Lot 7 H@NC - 127 Eagle Crest Court, Lillington, NC 27546

**THE APEX - LH
'GEORGIAN'**

11-14-23 - Initial Redlines

11-17-23 - Added 2 3/0 x 5/0 windows in Cafe as per contract Mod
11-15-23

THE APEX - LH
First Floor Plan 'Georgian'

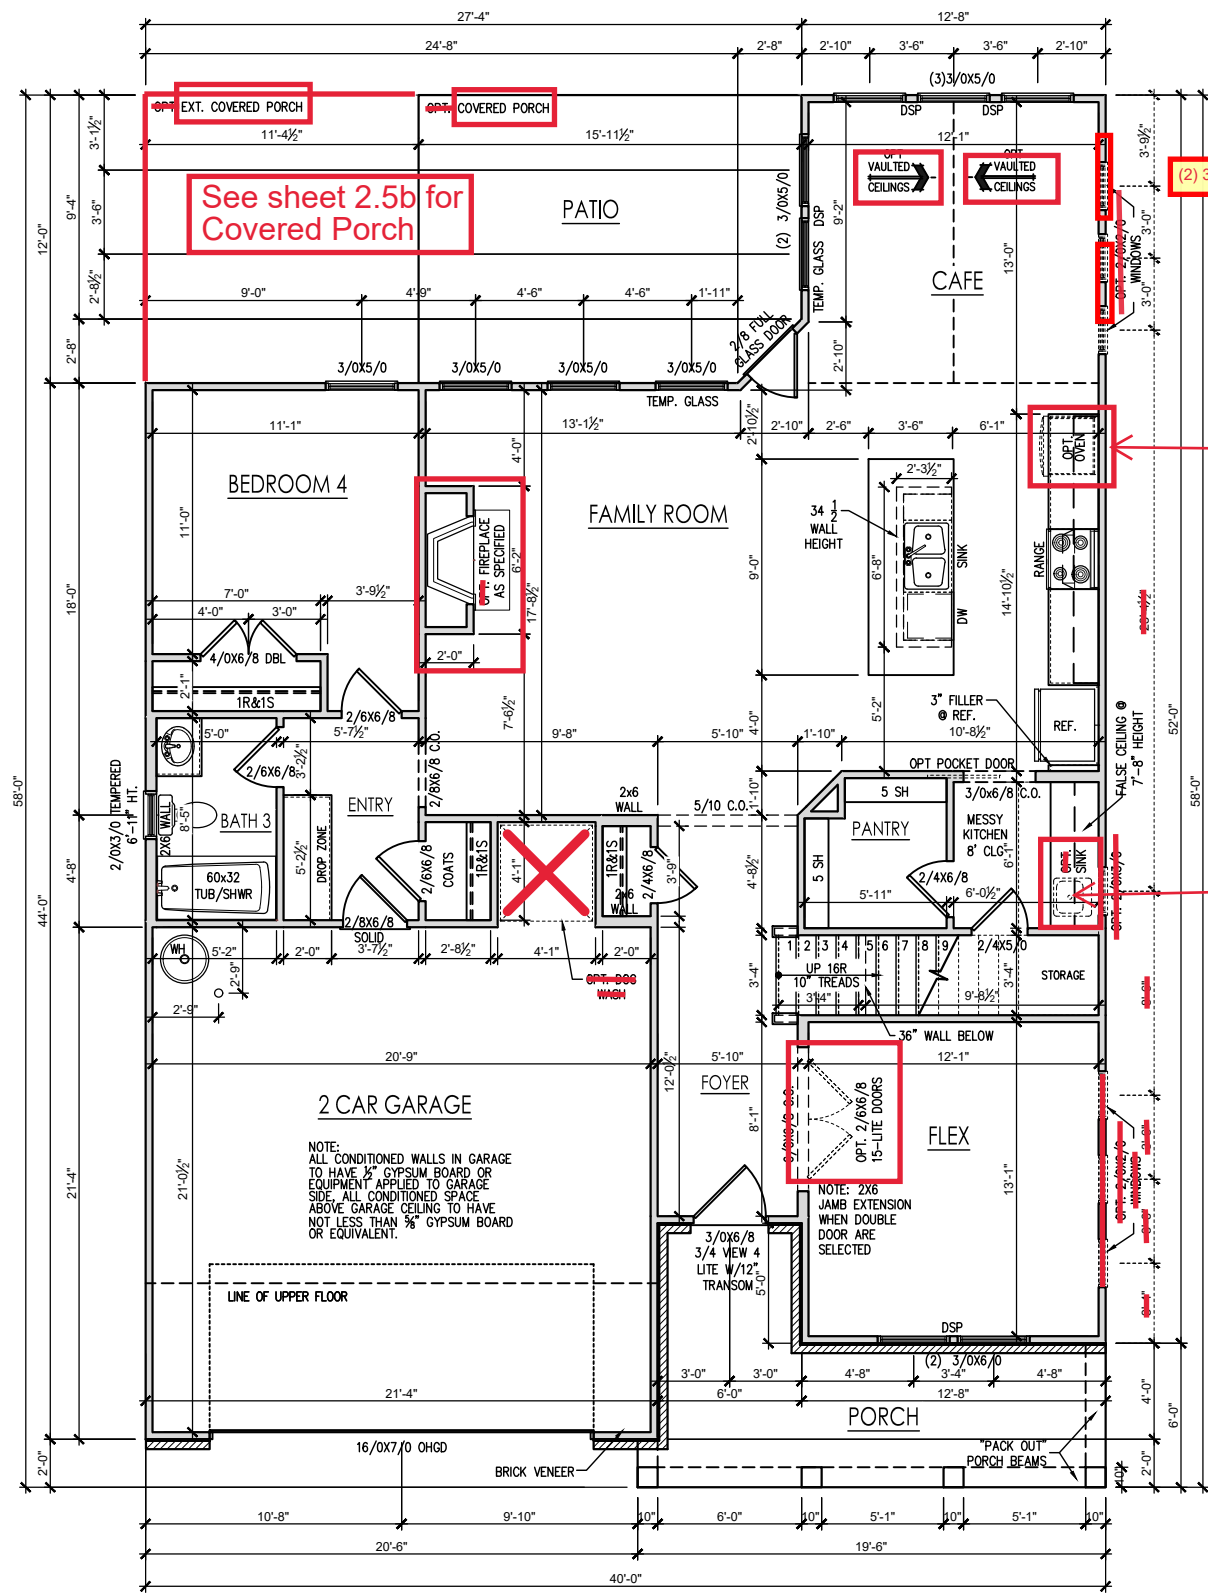
(2) 3/0 x 5/0 Windows no Grids

Include Oven

GAS Stub Out with Conversion kit

Gourmet Kitchen

Include Sink
